PRELIMINARY INVESTIGATION OF HYDROGEOLOGIC CONDITIONS,
AND SOIL AND GROUND-WATER CONTAMINATION,
AT THE VIRGINIA WOOD PRESERVING CORPORATION SITE,
RICHMOND, VIRGINIA

Report To
RENTOKIL, INC.
Norcross, Georgia

First draft - February 28, 1986
Second Draft - September 9, 1986

We are pleased to submit herewith our report on the
referenced investigation. Comments from EPA Region III on
the first draft of the report are addressed in Appendix 5.

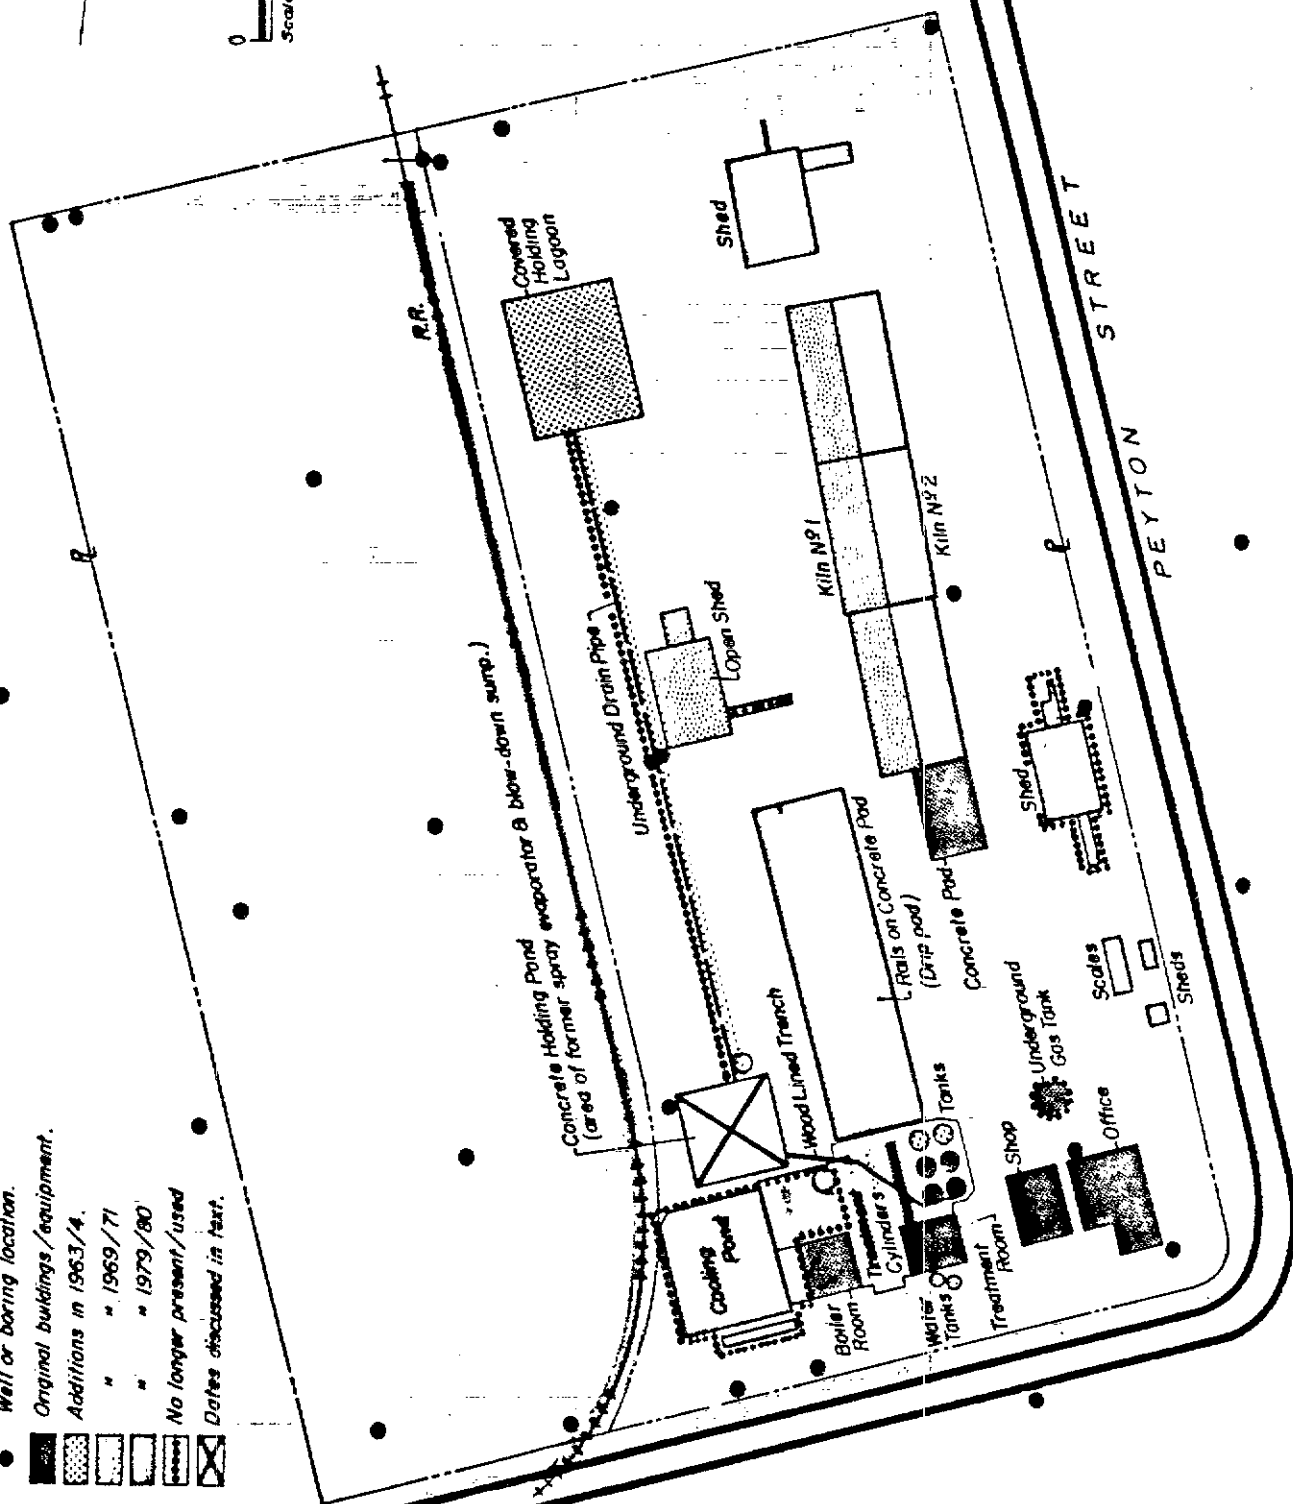
Page 15; Figure 2

All wells should be identified on each drawing.

Well numbers were not included on each figure so that pertinent data could be clearly noted. Please refer to Plate 2 for well number designation.

Fig. 7

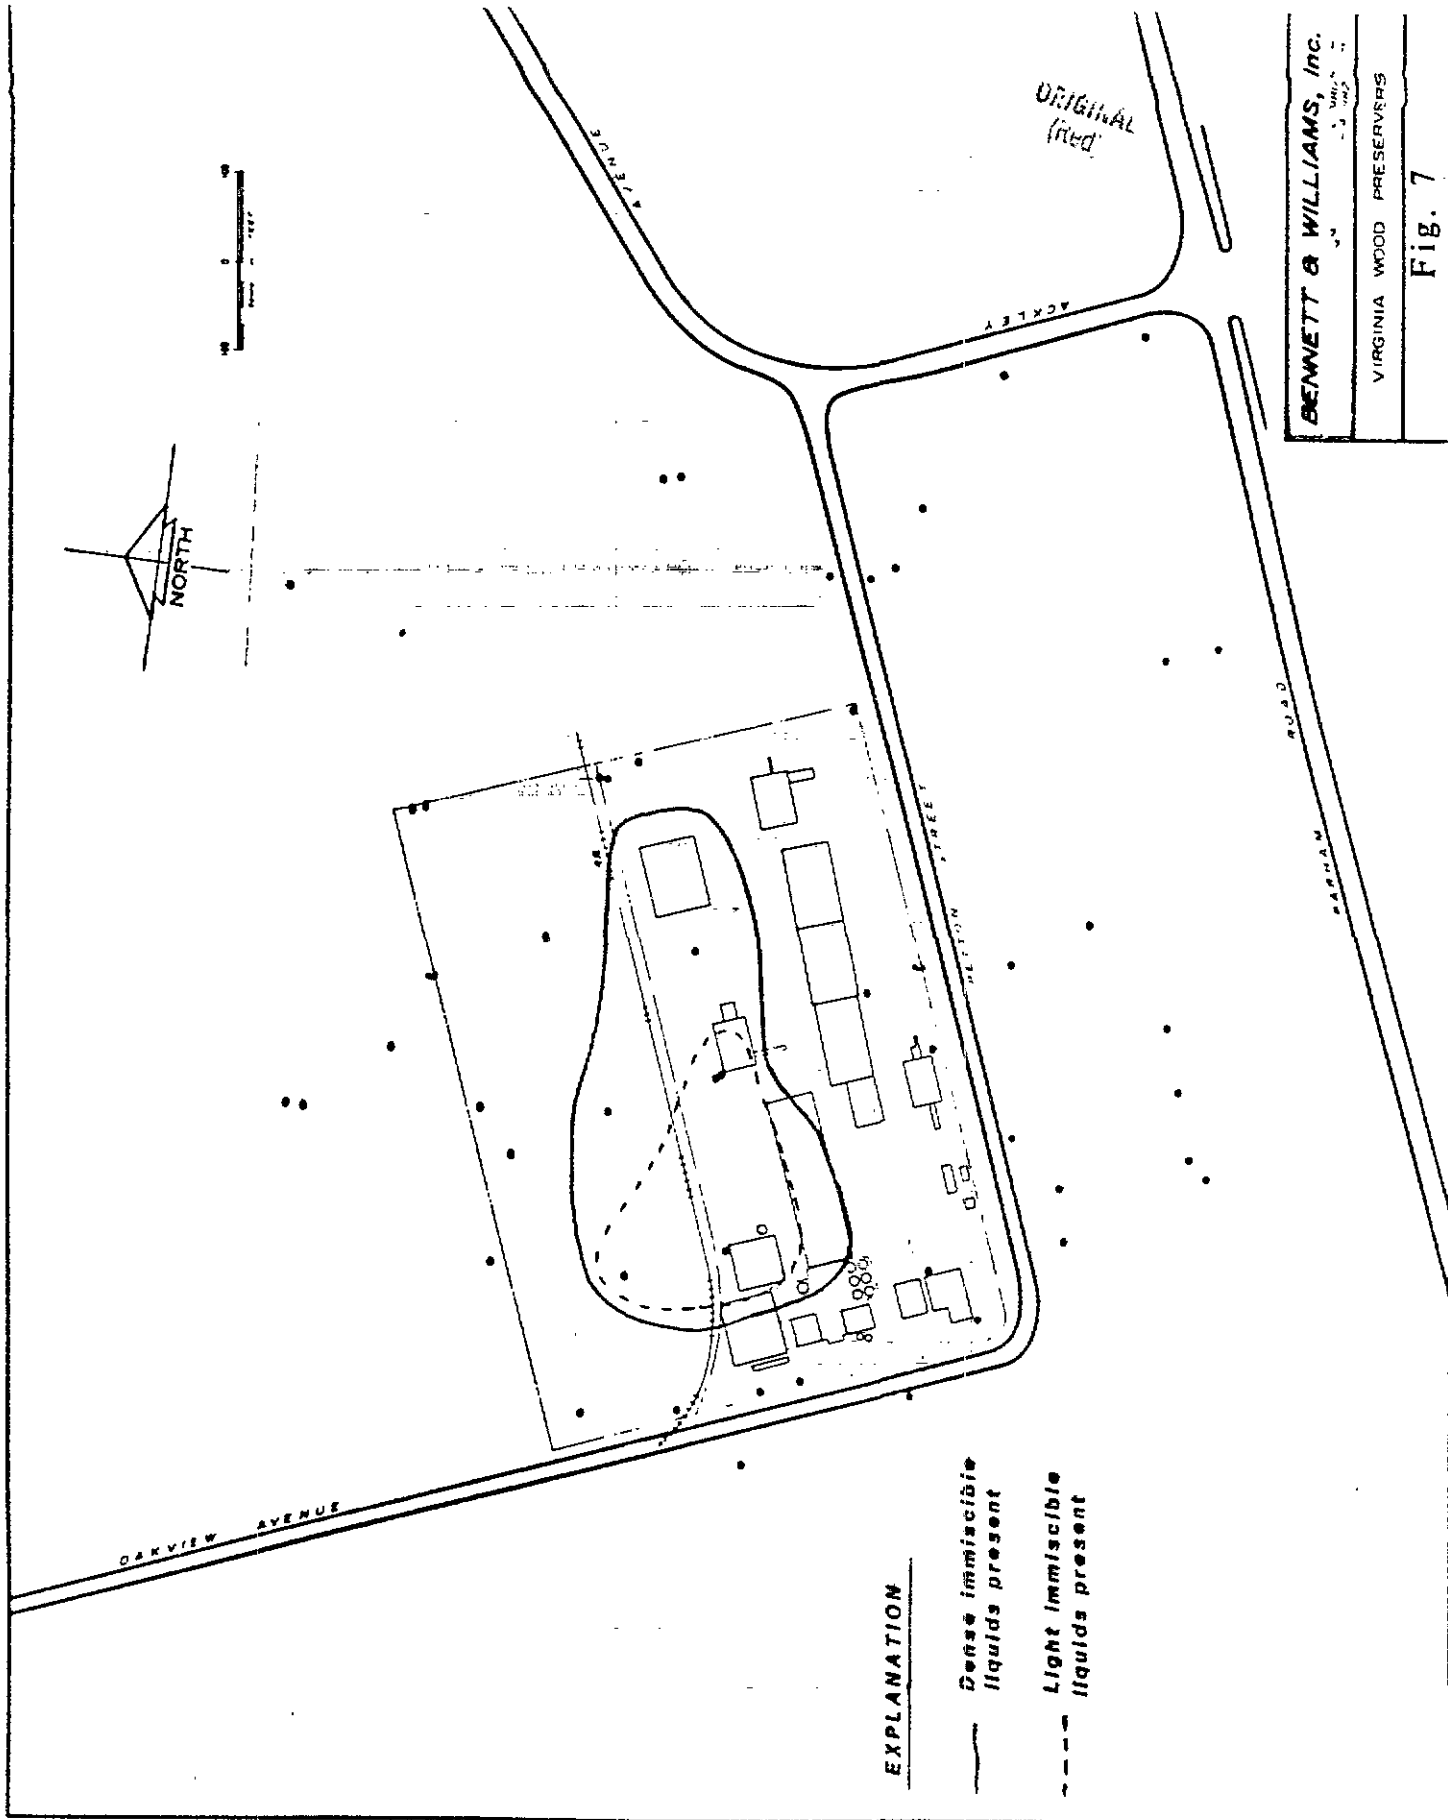
Does Figure 7 show 43,000 ft²?

Does Figure 7 show 134,000 ft²?

Fig. 10 - Total phenol concentrations, and probable extent of contamination, in ground water at the site.

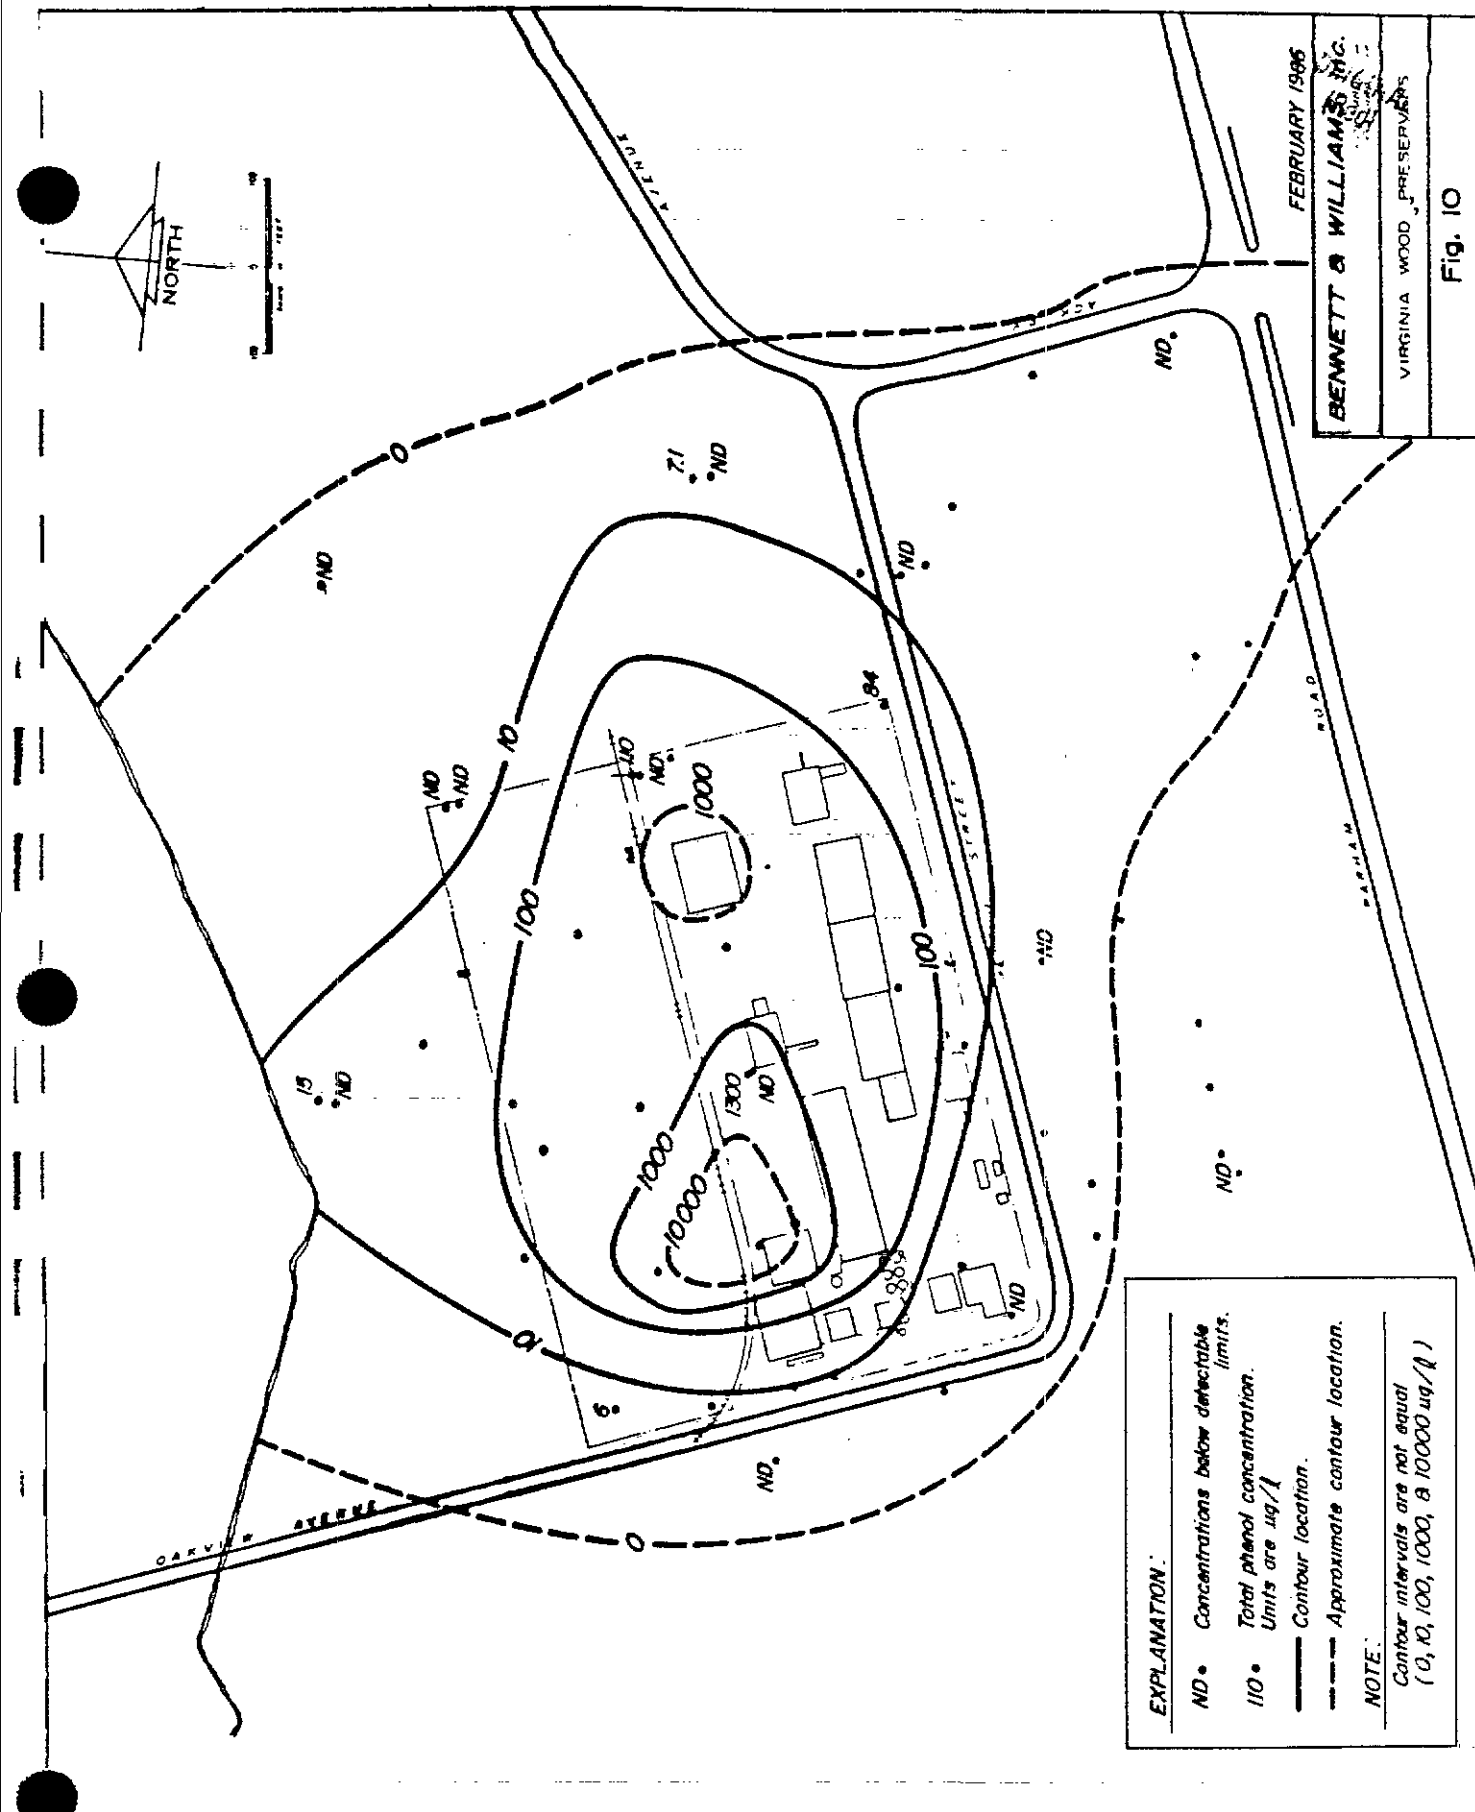
Any reason to suspect the high concentrations shown in Figure 10.

The areas of high concentration in Figure 10 are areas where immiscible liquids are present. We suspect that the contaminant concentrations will be close to the saturation point.
